Project	IEEE 802.16 Broadband Wireless Access Working Group < http://ieee802.org/16 >	
Title	Frame structure with UC regions	
Date Submitted	2008-03-10	
Source(s)	Kanchei (Ken) Loa, Tsung-Yu Tsai, Yung-Ting Lee, Youn-Tai Lee, Hua-Chiang Yin, Yi-Hsueh Tsai, Chun-Yen Hsu, Yi-Ting Lin, Chih-Wei Su, Shiann-Tsong Sheu, Yih Guang Jan, Yang-Han Lee, Ming-Hsueh Chuang, Hsien-Wei Tseng Institute for Information Industry 7F, No. 133, Sec. 4, Minsheng E. Rd., Taipei City 105, Taiwan	Voice: +886-2-66000100 E-mail: loa@iii.org.tw *< http://standards.ieee.org/faqs/affiliationFAQ.html >
Re:	Call for Comments on C80216m-08/118r1 from [frame] Rapporteur Group	
Abstract	This contribution proposes frame structures with the UC regions to C80216m-08/118r1.	
Purpose	For discussion and approval by IEEE 802.16 Working Group	
Notice	<i>This document does not represent the agreed views of the IEEE 802.16 Working Group or any of its subgroups. It represents only the views of the participants listed in the "Source(s)" field above. It is offered as a basis for discussion. It is not binding on the contributor(s), who reserve(s) the right to add, amend or withdraw material contained herein.</i>

Frame structure

Figure 11.4-5-1: Proposed Frame Structures in TDD mode

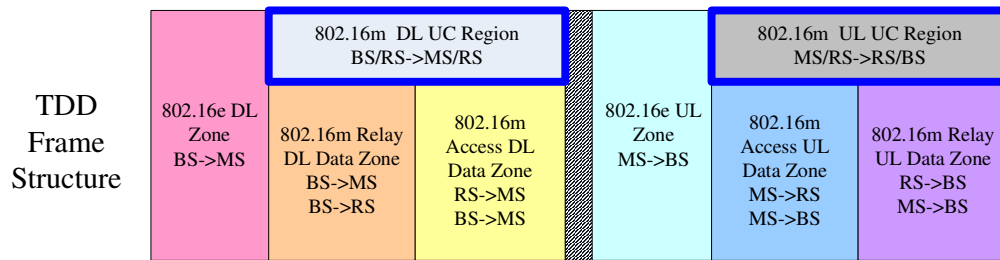
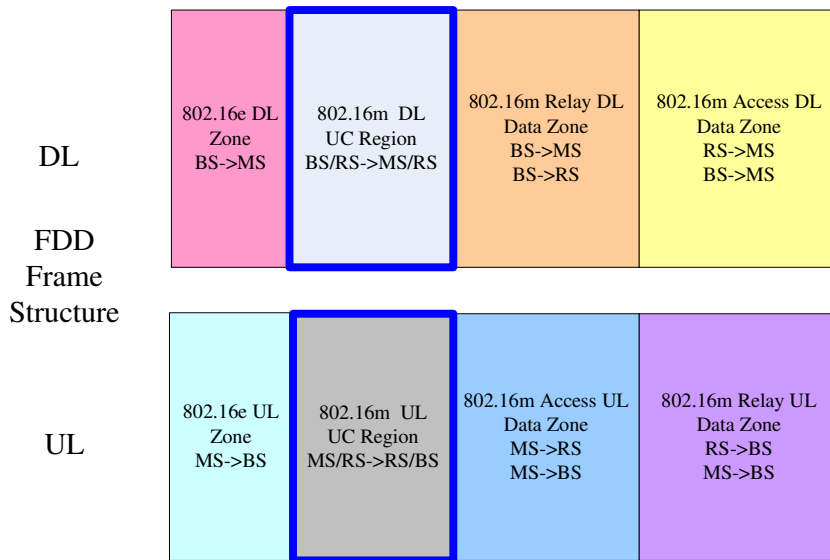
[Insert Subclause 11.4.4.1as follows:]

In order to facilitate efficient and fast exchanges of control signals such as HO related signals, network entry related signals, HARQ related signals and CQI report signals in 16m systems with relays, the Universal Control (UC) regions are defined in the frame structure by either zone or frequency allocations. Figure 11.4-5-1(a) depicts an example of UC region allocations for TDD frame structure by zone, whereas Figure 11.4-5-1(b) depicts an example of UC region allocations for TDD frame structure by frequency. Figure 11.4-6-1(a) depicts

(b) Frame structure with frequency-based UC regions in FDD mode
Figure 11.4-6-1: Proposed Frame Structures in FDD mode

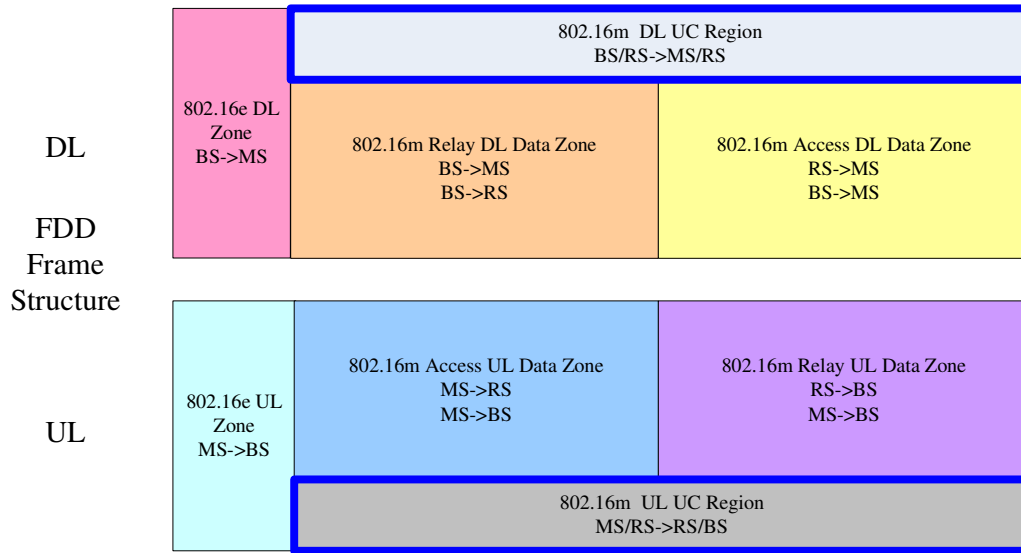
an example of UC region allocations for FDD frame structure by zone, whereas Figure 11.4-6-1(b) depicts an example of UC region allocations for FDD frame structure by frequency.
